Springfield Airport Authority

Request For Proposals Construction and Removal of Parking Lot
Fence

ADDENDUM NO. 1

October 24, 2017

FENCE DETAILS

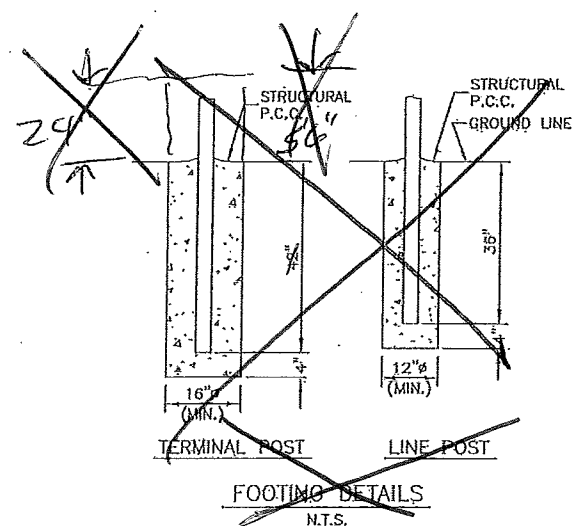
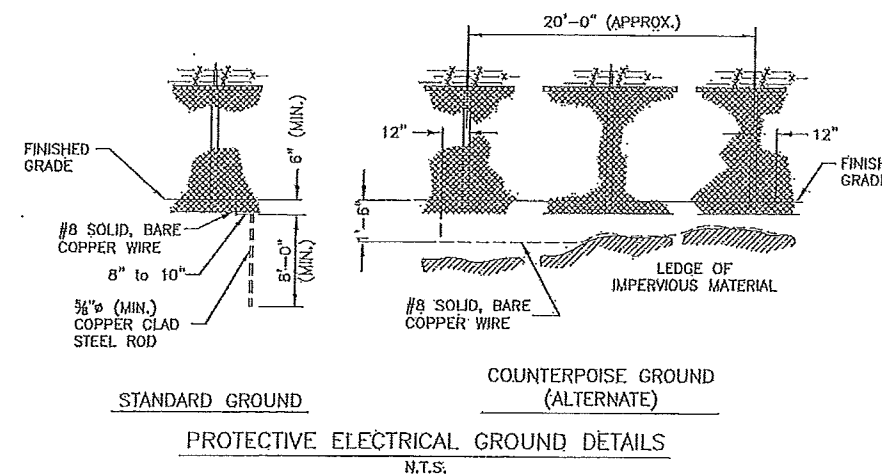
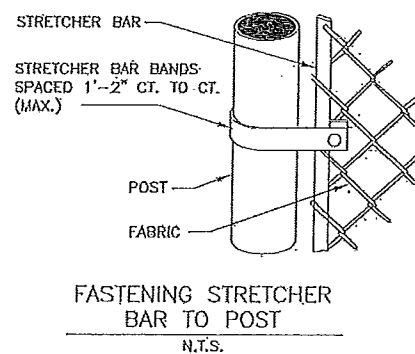
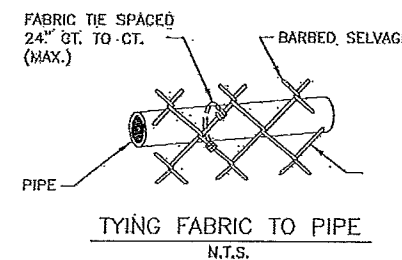
2. Note changes to concrete Footing Detail on Sheet 2 attached.
3. It is the contractors responsibility to call for a Julie locate and to call Airport staff to locate utilities in the work area.
